ROAD SAFETY AUDIT: 2200 WEST IN LAYTON (GORDON AVE TO ANTELOPE DR)

8/24/2026

Figure 7: Insights and Issues Summary

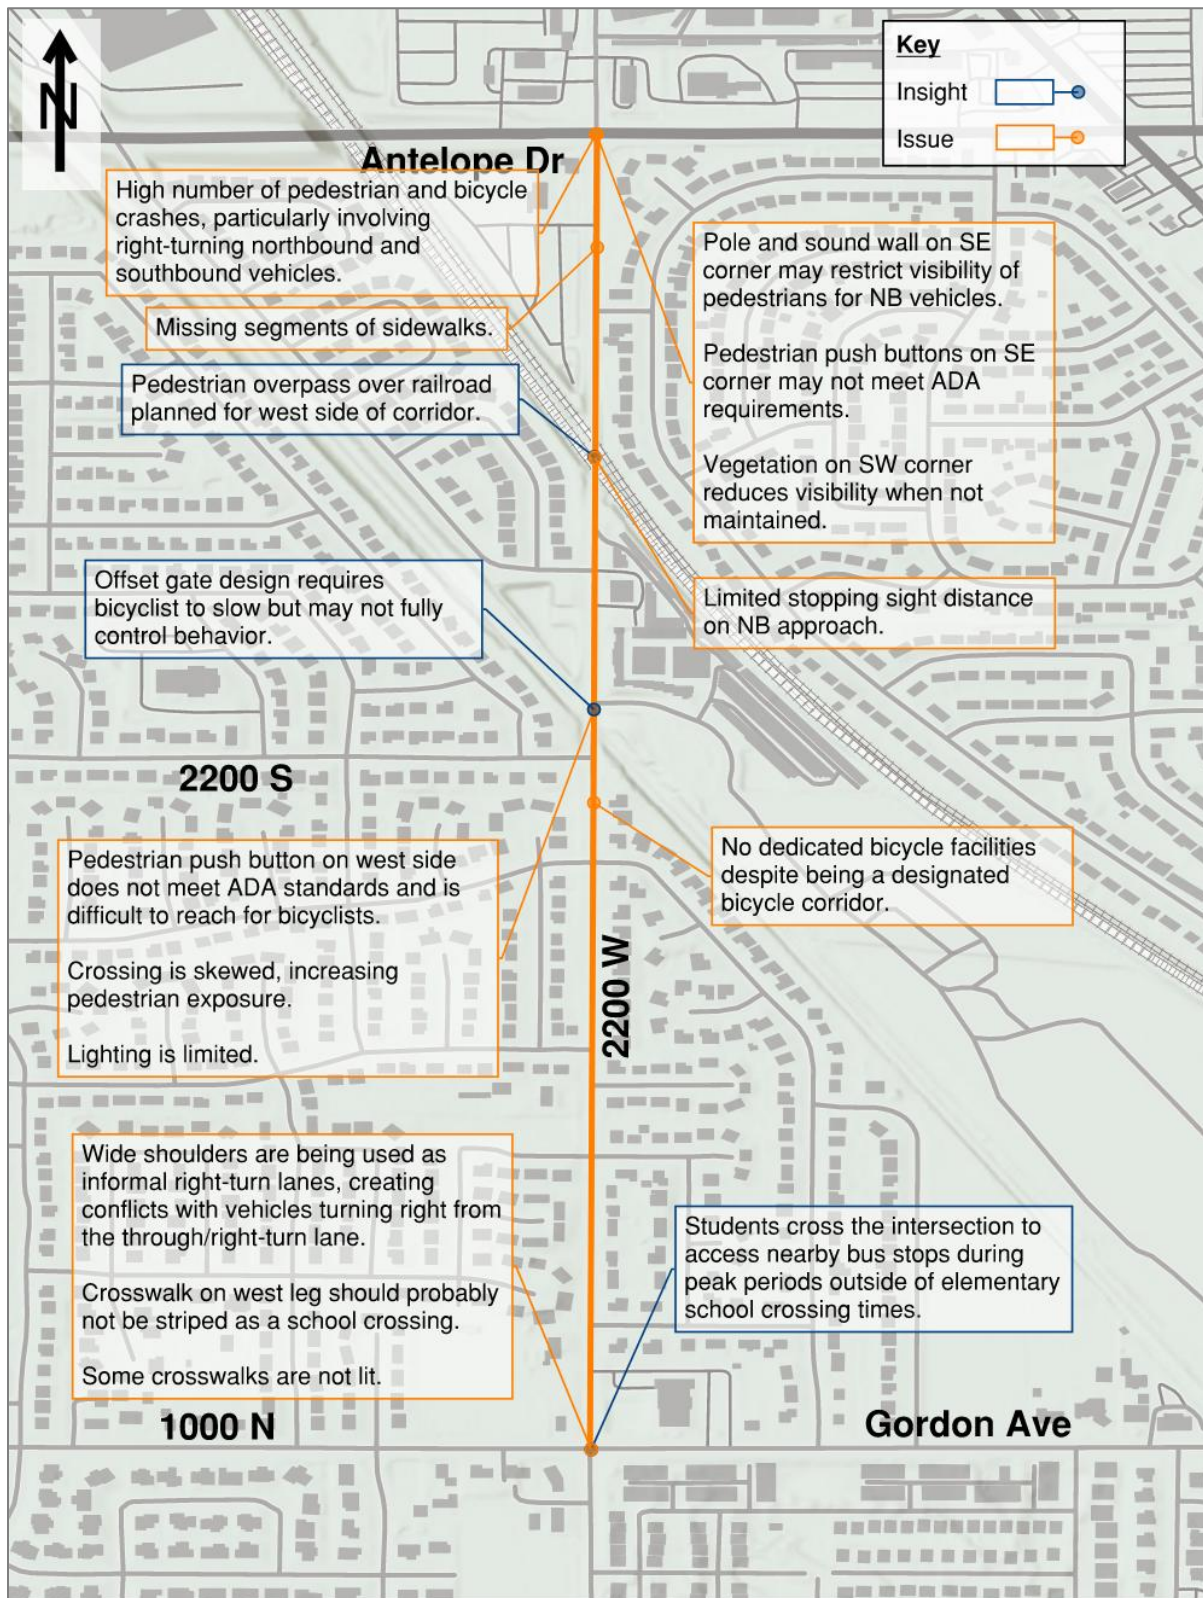
A summary map of all location-specific insights and issues is shown in **Figure 7**. Insights are not necessarily safety concerns, but observations or background information that inform recommended safety measures. Issues are safety concerns which the suggested measures intend to address.

Issue #1: Large segments of sidewalk are missing north of the rail crossing.

Issue #2: Limited or inconsistent lighting along corridor segments and at crossings.

Issue #3: Pedestrian ramps are non-directional and do not meet current ADA standards.

Issue #4: Lack of dedicated bicycle facilities despite corridor identified in city bike plans.

Issue #5: Speeds exceed posted speed limit

Issue #1: Limited sight distance for westbound left-turning vehicles, especially when opposing vehicles (e.g., buses) are present.

Issue #2: Pole and sound wall on southeast corner may restrict visibility of pedestrians for northbound drivers.

Issue #3: Vegetation on southwest corner reduces visibility when not maintained.

Issue #4: Pedestrian push buttons on southeast and southwest corners are located far from ramps and may not meet ADA accessibility expectations; ramps may not be ADA compliant.

Issue #5: High number of pedestrian and bicycle crashes, particularly involving northbound and southbound right-turning vehicles.

Issue #6: Long queues and observed cycle failures for turning movements during peak periods (particularly eastbound left turn in AM, northbound left turn in PM).

Issue #7: High presence of school buses contributing to visibility and operational challenges.

Issue #8: There are no sidewalks on the south leg, but pedestrian activity is evidenced by worn footpaths on both sides of the road.

Issue #1: There are 80+ train crossings per day (freight and commuter rail) that create frequent interruptions to traffic flow. Future double tracking of commuter rail line will result in increased crossing events. Emergency response is impacted by railroad crossings, requiring rerouting when trains are present.

Issue #2: Limited stopping sight distance on northbound approach (~180 feet).

Issue #3: Pedestrians and bicyclists continue to cross at-grade despite lack of crossing infrastructure.

Issue #4: Pedestrians should be guided to west side of the road to encourage use of the future pedestrian bridge.

Issue #5: Sidewalk on southwest quadrant is overgrown and virtually unusable.

Issue #1: Pedestrian push button location on west side does not meet ADA standards and is difficult to reach, especially for cyclists.

Issue #2: Trail users frequently cross without activating the signal.

Issue #3: Crossing is on the diagonal, increasing exposure time (but cyclists prefer this).

Issue #4: Lighting is limited, particularly on the east side of the crossing.

Issue #5: Offset gate design requires bicyclists to slow but may not fully control behavior.

Issue #1: Doghouse (Type V) signal heads on all approaches could be updated; switching to FYA would likely require an extension.

Issue #2: Wide shoulders are being used as informal right-turn lanes, creating conflicts with vehicles turning right from the through/right-turn lane.

Issue #3: School crossing on west leg may not be warranted.

Issue #4: Some crosswalks are not currently illuminated. Luminaires are only present on two corners.

- Complete missing sections of sidewalk

- Improve lighting

- Update pedestrian ramps to meet ADA requirements

- Stripe bike lanes

- Install buffered bike lanes

- Stripe bike lanes
- Consider lowering the speed limit

- Install a raised median at the Denver and Rio Grand Western rail trail crossing

- Evaluate protected-only left-turn phasing

- Implement Leading Pedestrian Intervals
- Prohibit right-turn on red during pedestrian phase, particularly for the northbound and southbound

- Relocate pole and sound wall on southeast corner

- Maintain/remove vegetation on southwest corner

- Update pedestrian ramps
- Improve pedestrian push button access

- Implement Leading Pedestrian Intervals
- Evaluate protected-only left-turn phasing
- Prohibit right-turn on red during pedestrian phase, particularly for the northbound and southbound

- Evaluate permitted-protected (flashing yellow arrow) left-turn phasing for the northbound and southbound
- Evaluate signal phasing and update signal timing

- Evaluate protected-only left-turn phasing

- Install sidewalks on both sides of south leg

- Full roadway grade separation

- Full roadway grade separation
- Regrade roadway south of crossing to increase sight distance

- Install pedestrian bridge

- Trim landscaping and improve sidewalk on southwest quadrant
- Install a crosswalk and signage directing pedestrians to the west side

- Remove sidewalk on southeast quadrant

- Trim landscaping and improve sidewalk on southwest quadrant

- Relocate signs and obstacles
- Pave approach to pedestrian push button

- Relocate pedestrian push button to be ADA and bicycle accessible

- Realign crossing to be perpendicular & install fencing to direct users

- Grade separate the trail (while ensuring trail user access to 2200 W is still maintained)

- Realign crossing to be perpendicular & install fencing to direct users
- Raised median through crossing

- Improve lighting

- Realign crossing to be perpendicular & install fencing to direct users

- Grade separate the trail (while ensuring trail user access to 2200 W is still maintained)

- Implement Flashing Yellow Arrow (FYA) signal phasing

- Stripe hatch marks in the shoulder; install flex posts

- Install bulb-outs

- Evaluate crosswalk striping; restripe as warranted

- Improve lighting
